**EXPLANATION OF SIGNIFICANT DIFFERENCES
RECORD OF DECISION – OPERABLE UNIT 2
KIMBERTON SUPERFUND SITE**

Site Name: Kimberton Superfund Site (Site)

Statement of Purpose

Figure 1-2 – Lagoon and Septic Pit Location

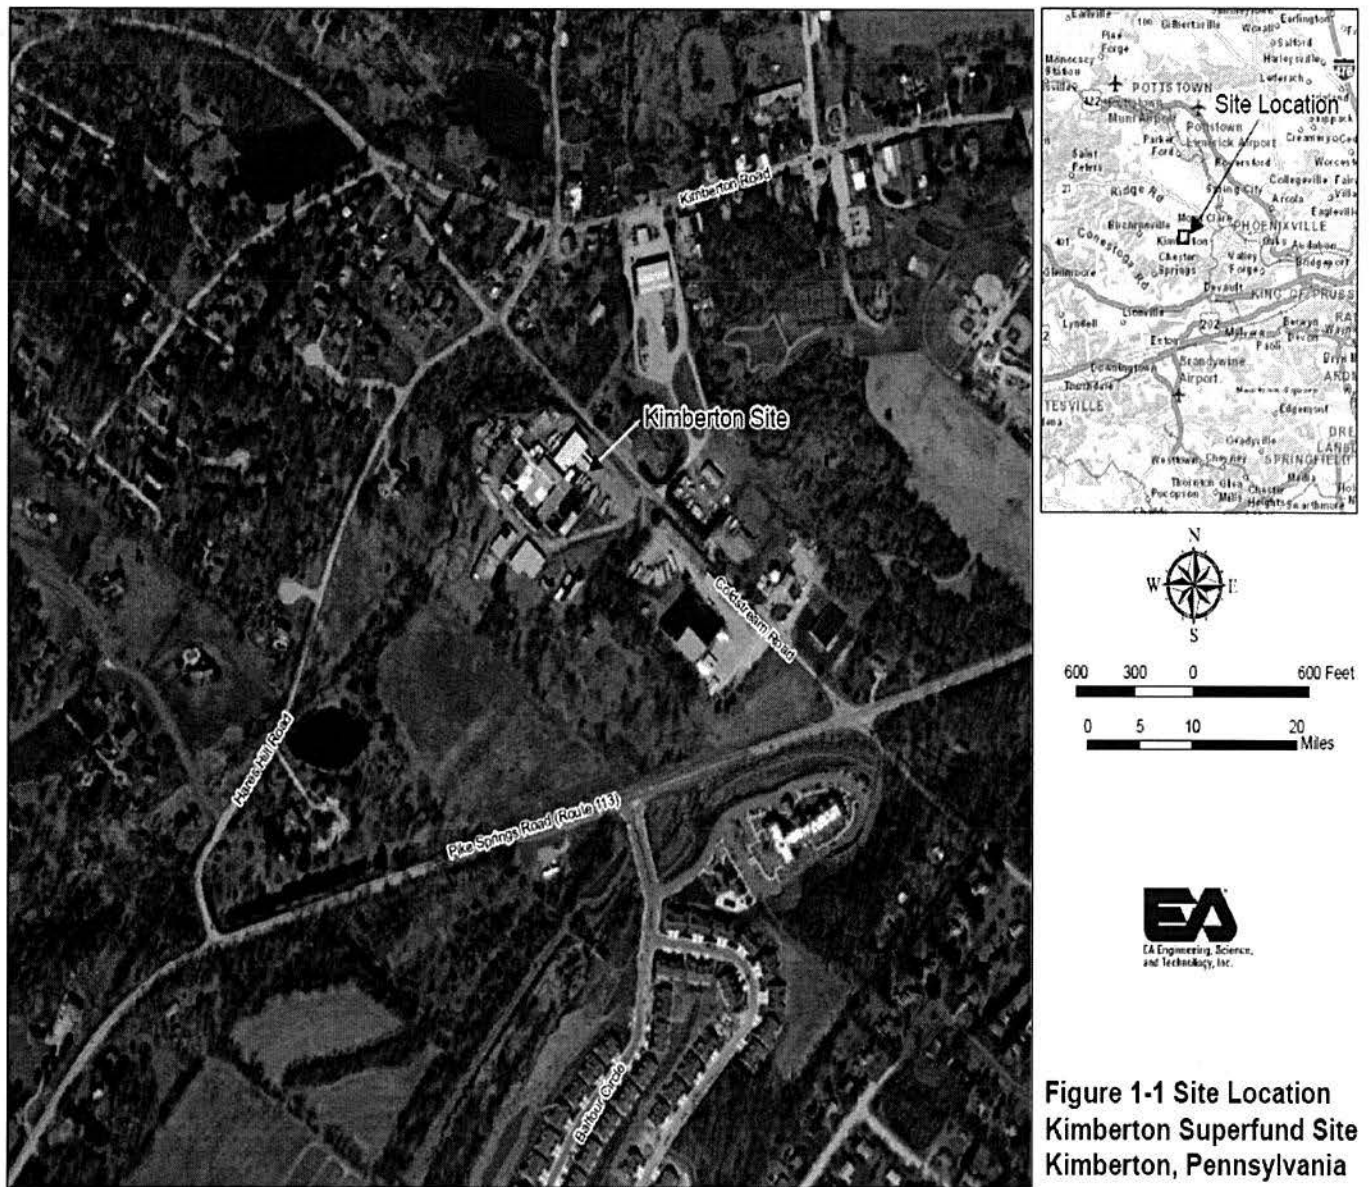
During Ciba's manufacturing operations, waste solvents were disposed of in several unlined lagoons (Figure 1-2). Nine lagoons were initially identified; however, an area originally identified as Lagoon #5 was determined to contain construction debris and sampling indicated that the area was not utilized for waste solvent disposal. Thus, there is no Lagoon #5 identified in Figure 1-2. The former septic pit, also shown on Figure 1-2, was used for wastewater from Site operations. It was abandoned in 1977 when the roof supports collapsed and the overlying parking lot caved in. The septic pit was backfilled with material including drums reportedly containing off specification asphaltic materials.

Based on historical data found in the *Remedial Investigation Report - October 1988*, EPA has determined that there is a potential for the residual VOC contamination in the soils within the former lagoons and septic pit areas to impact groundwater at the Site if the current soil caps were to be disturbed. The historical data was compared to Site-specific criteria developed with the Soil Screening and Remediation Goal (SSRG) tool. The SSRG tool is a model that allows the user to input a number of site specific parameters to generate a maximum contaminant concentration in soil that would not result in an exceedance of the MCL for that contaminant in groundwater.

3. There shall be no disturbance of the soil caps over the former lagoon and former septic pit areas by filling, drilling, excavation, removal of topsoil, rocks or minerals, or change in topography or any other physical alteration unless it is demonstrated to EPA that such disturbances will not pose a threat to human health or the environment or adversely affect or interfere with the OU2 Selected Remedy, and EPA provides prior written approval for such disturbances;

4. Installation of a physical barrier, and installation of permanent markers identifying those areas, such as fencing, around the former lagoon and former septic pit areas to prevent access by trespassers;
5. No vehicle movement that could impact the soil caps shall take place within the fenced in former lagoon and former septic areas without prior written approval by EPA.
6. The Site shall not be used in a way that will adversely impact the Selected Remedy or interfere with the integrity and protectiveness of either the soils caps, groundwater monitoring wells, groundwater extraction, conveyance, and treatment system or any component of the Selected Remedy without prior written approval by EPA.

Figure 1-3 – 2010 TCE Plume and VI AOI Map

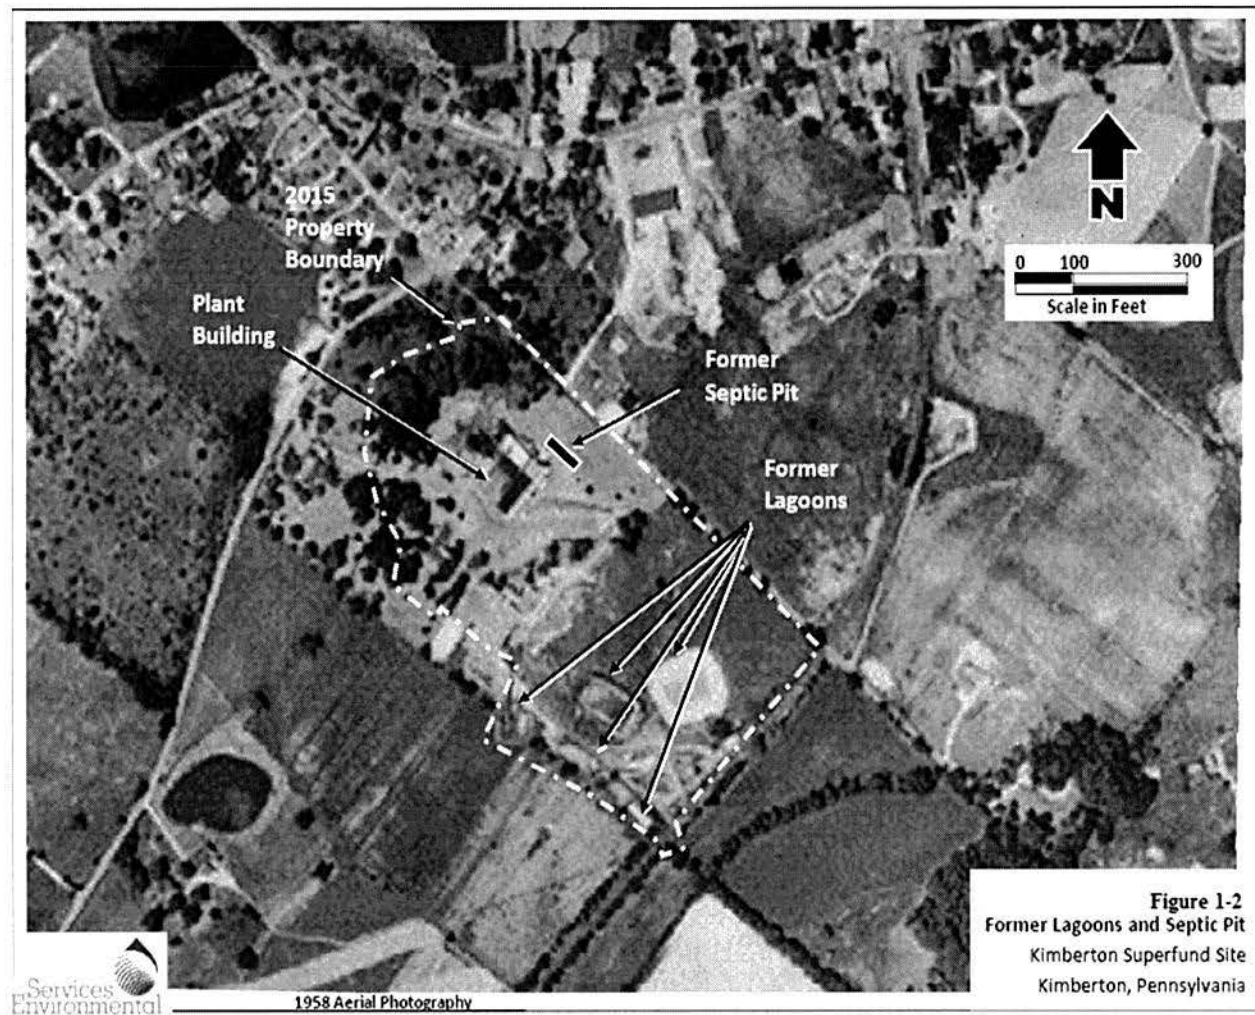
The PRPs completed a Vapor Intrusion (VI) investigation in 2011. The VI investigation identified all occupied buildings within the boundaries of the contaminated groundwater plume and a 100-foot buffer area (Figure 1-3). Potential off-site VI concerns are related to volatilization of TCE from the groundwater. Figure 1-3 shows the boundaries of the TCE plume in 2010 and

1. Implementation of Additional Institutional Controls:
 - a. Require VI mitigation within the AOI;
 - b. Prevent disturbance of soil caps at former lagoons and septic pit; and
 - c. Prevent disturbance of components of the groundwater extraction and treatment system.
2. Change in Groundwater Performance Standards:
 - a. Replace natural background performance standards with current MCLs; and
 - b. Performance of a cumulative risk assessment once MCLs are achieved.

As indicated in Section II. B., History of Contamination, a VI investigation was performed at current structures on the Site property and at residential locations within the AOI for VI. Since that VI investigation was performed, the extent of the groundwater contamination plume has been reduced, thereby also reducing the AOI for VI, as depicted on Figure 1-4. Unacceptable risk at existing structures was addressed via the installation of VI mitigation systems at two locations, the Henry warehouse and an off-Site residence. Therefore, ICs are necessary to ensure operation and maintenance of these mitigation systems. Additionally, due to the potential for unacceptable VI risks in buildings constructed within the current AOI in the future, ICs are necessary to require the installation, operation, and maintenance of VI mitigation systems in any such building.

2. No new structure(s) shall be constructed within the VI AOI without the installation of vapor mitigation measures that ensure protection from potential VI of Site related COCs into the structure(s). However, if it is demonstrated to EPA that vapor mitigation measures are not necessary to protect human health or the environment, EPA will provide written approval for construction without vapor mitigation measures. Prior to occupancy, the indoor air in the building shall be tested. If the indoor air concentrations of Site related COCs are equal to or exceed EPA-risk based criteria, the mitigation measures shall be activated and operated until such time as indoor air concentrations no longer exceed EPA-risk based criteria;
